**Landscape Review Committee  
ZOOM Online Meeting  
Wednesday, December 16, 2020 - 12:00 PM**

**DATE:** December 16, 2020  
**TO:** Landscape Review Committee Members  
**FROM:** Jamie Fleckenstein, Associate Planner  
**SUBJECT:** Agenda Item 4A - Street Tree Removal Application (L 36-20)

An application to remove two (2) Maple street trees adjacent to 1575 NW Yohn Ranch Drive (L 36-20) to be reviewed by the Landscape Review Committee. Staff has reviewed the application for consistency with the applicable criteria, and recommends approval of the application, subject to the conditions specified in the attached Decision Document, including requiring one (1) replacement street tree, and repairing any damaged sidewalk.

**Figure 4: Existing Trees 1 & 2**

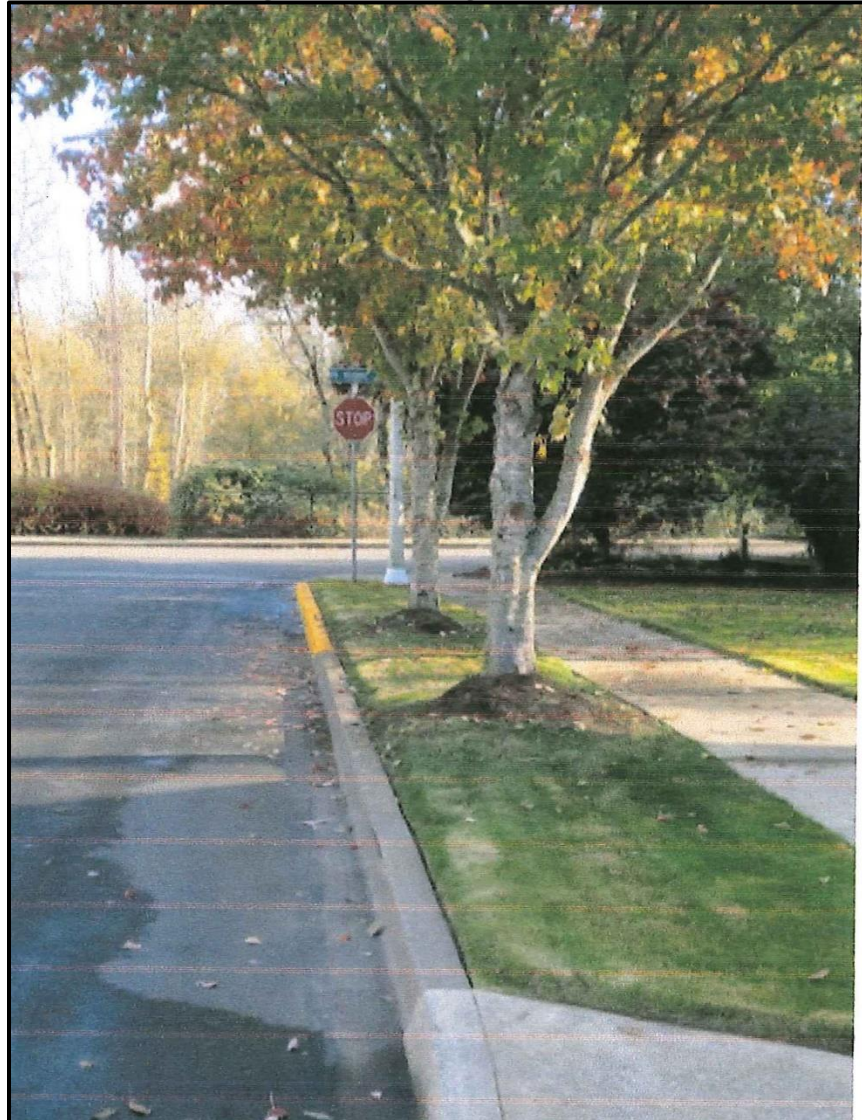
1. The trees in question appears to be a maple variety and are approximately 8" DBH respectively.
2. The trees are planted in 5 foot planter strip with irrigated turf as ground cover
3. There are no overhead facility conflicts.
4. There are no tree related damages to the curb/gutter.
5. The trees appear to be beginning to lift the adjacent sidewalk.
6. Both trees show excessive root mounding indicative of shallow planting.

1. Given the planting conditions and the sidewalk impacts, staff would recommend approval of this request.
2. There is adequate spacing to replant two trees; however the applicant is requesting that only one be replaced, based on improving stop sign visibility. Public Works would defer to Planning to insure that replacement tree spacing is consistent with the approved street tree plan for this subdivision, but would note that increasing the distance from the tree to the sign would stop sign visibility.

**Figure 5 (Proposed Replacement Tree Location)**

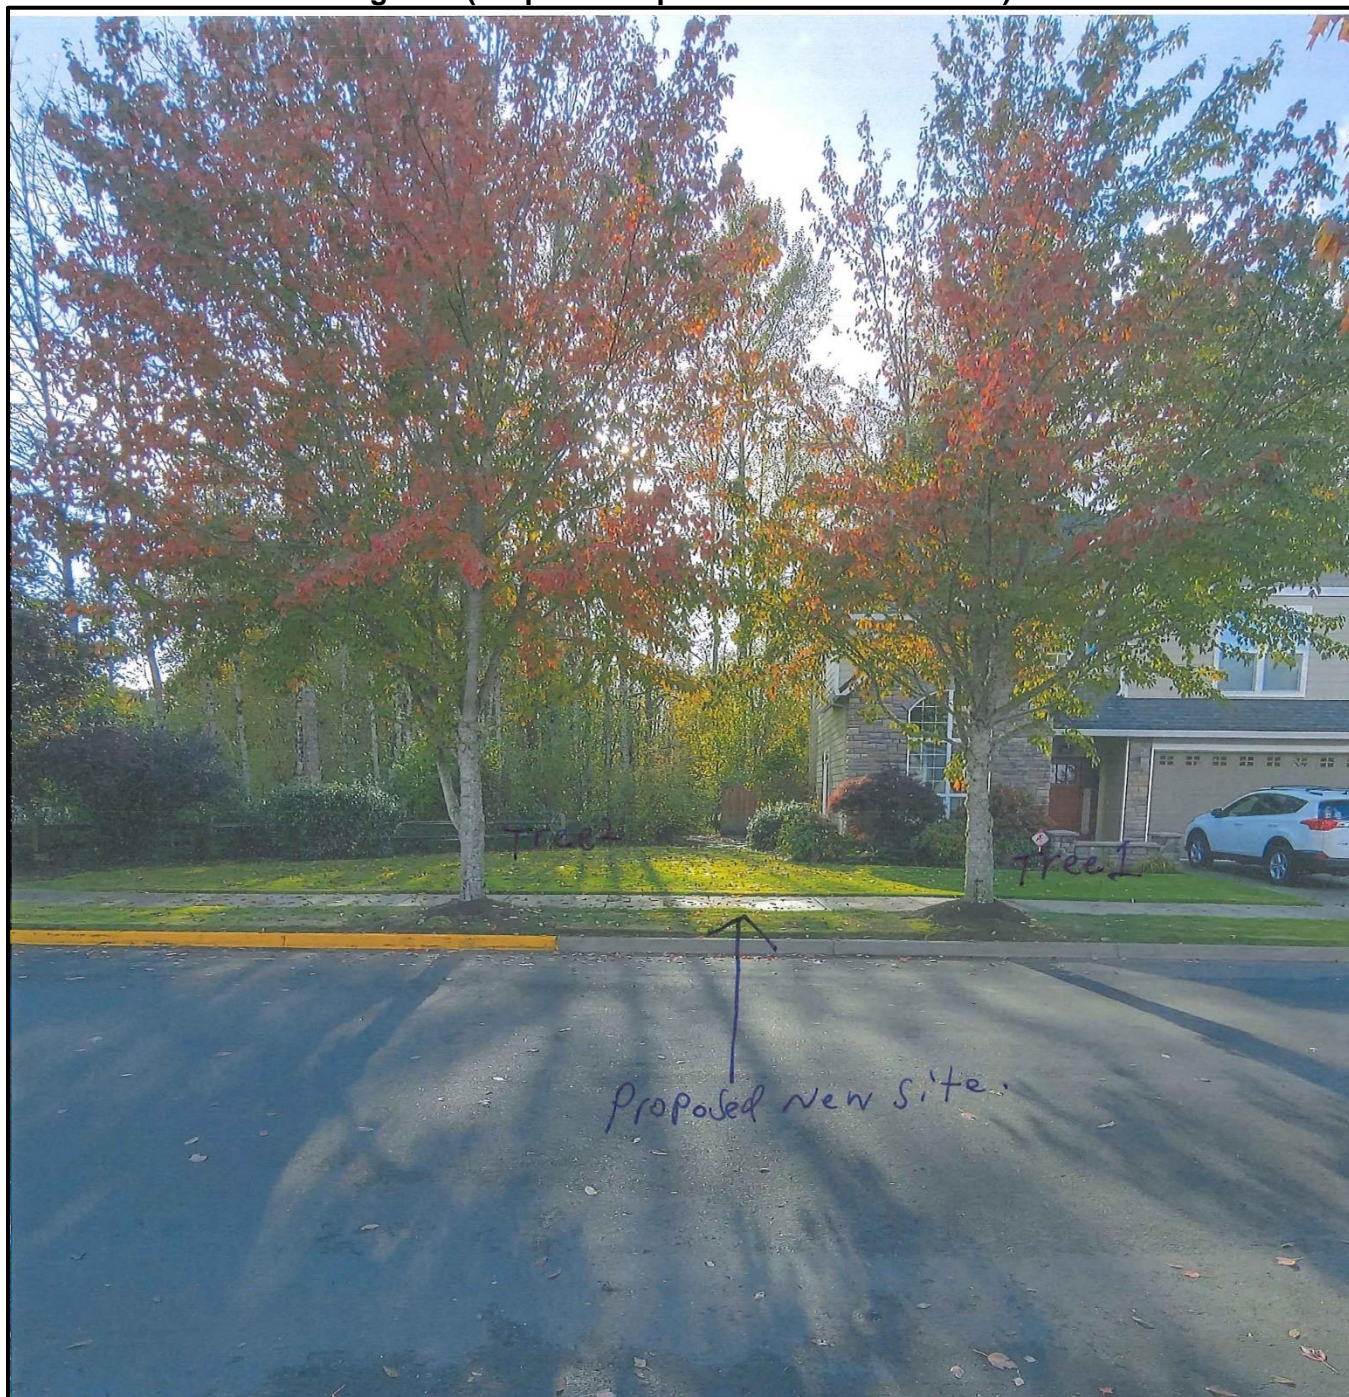
**FINDING: SATISFIED WITH CONDITION OF APPROVAL #4.** The two (2) trees in the Yohn Ranch Drive right-of-way are located in a curb-side planter strip that is approximately five (5) feet wide. A stop sign and street light are located at the intersection of Yohn Ranch Drive and Meadows Drive. Underground power is buried in the area. The application requests that one (1) replacement tree be planted between the two existing trees to improve visibility of the stop sign at the intersection. The site plan indicates a sewer lateral west of existing Tree #1. Required setbacks from the sewer line would prevent the placement of a second tree between the first replacement tree and the driveway.

**CONDITION FOR FINDING:** That one (1) replacement street tree be planted in the NW Yohn Ranch Drive planter strip. The tree shall be a *Ginkgo biloba* 'Magyar' (Magyar Ginkgo), per the applicant's request, or a recommended medium street tree from the McMinnville Street Tree List, or other species/variety approved by the McMinnville Landscape Review Committee.
